Subject: Puente Power Project (15-AFC-01)
Data Adequacy Supplemental Response

Application for Certification
(15-AFC-01)

Puente Power Project (P3)
Oxnard, CA

Data Adequacy Supplemental Response

REVISED FIGURE 2.7-5a

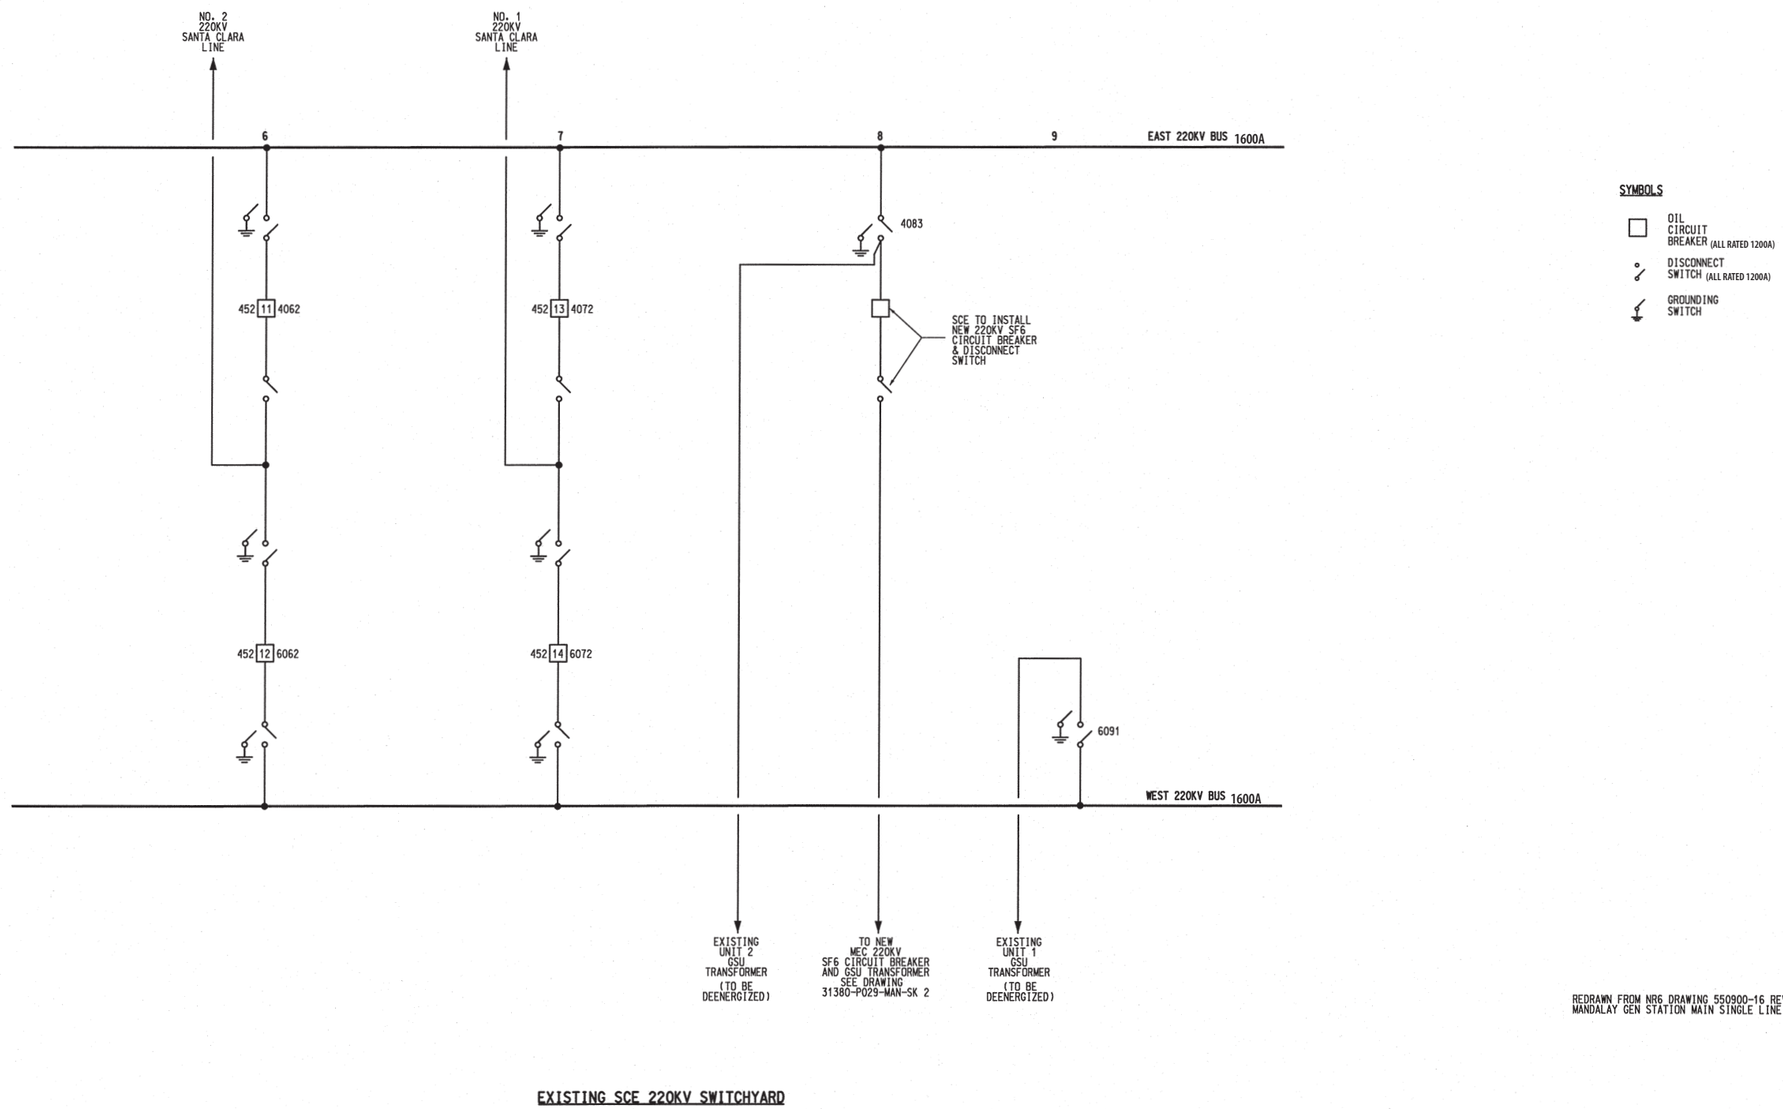
1. Resubmit Figure 2.7-5a. Show all equipment ratings including bay arrangement of the breakers, disconnect switches, buses, and etc. which are required for the addition of the project.

1. See attached Revised Figure 2.7-5a.

REVISED FIGURE 2.7-5b

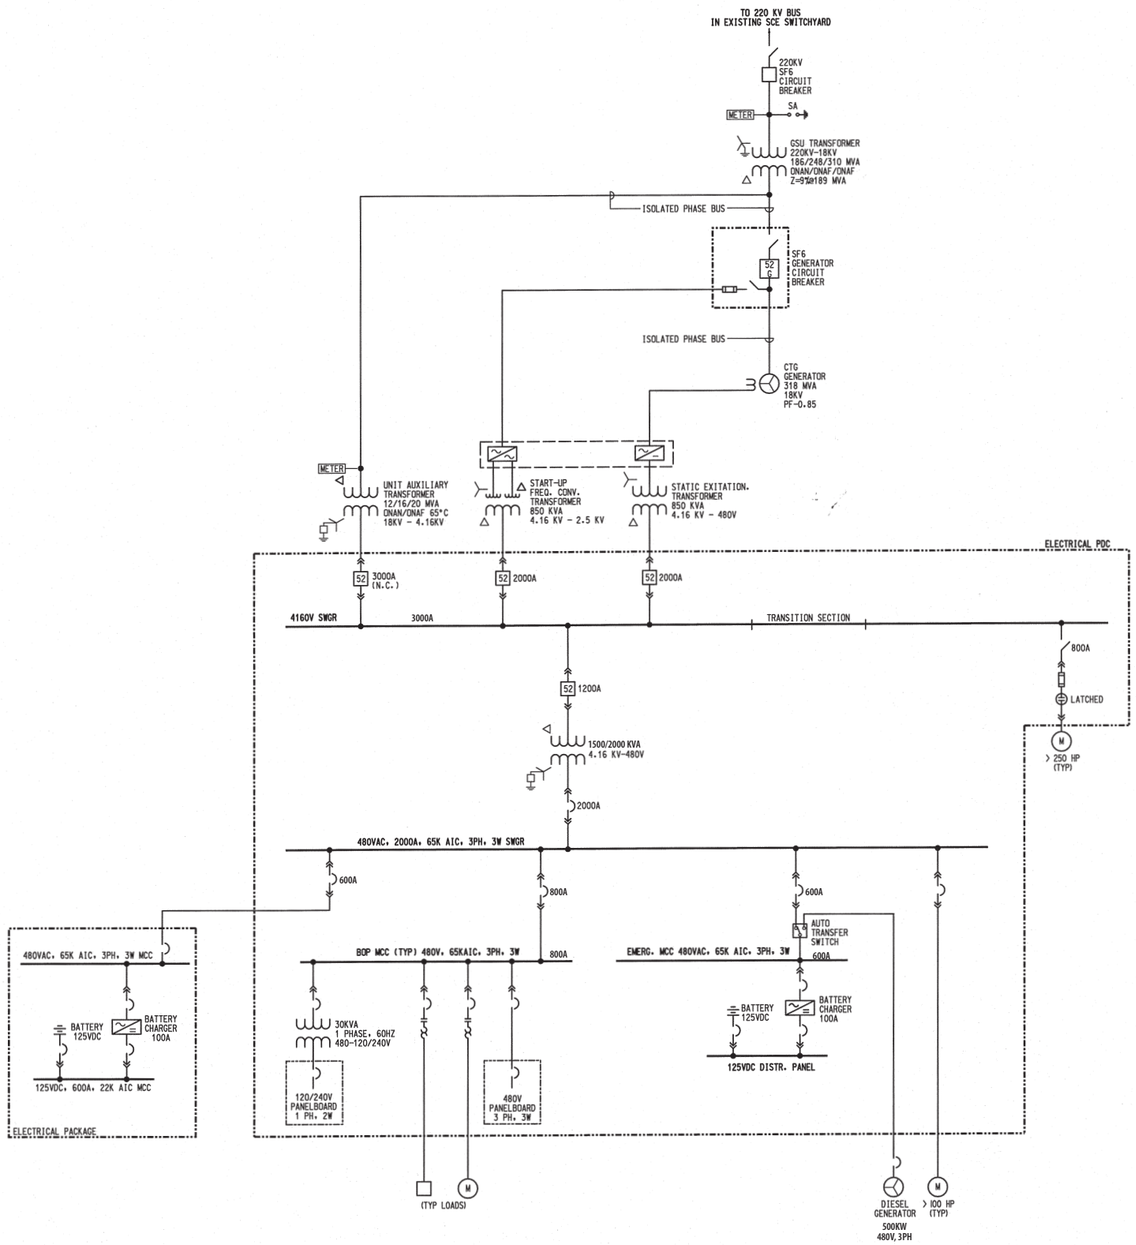
2. Resubmit Figure 2.7-5b. Show all equipment ratings including generators, transformers, isolated phase bus, circuit breakers, disconnect switches, and etc. which required for the project.

2. See attached Revised Figure 2.7-5b.
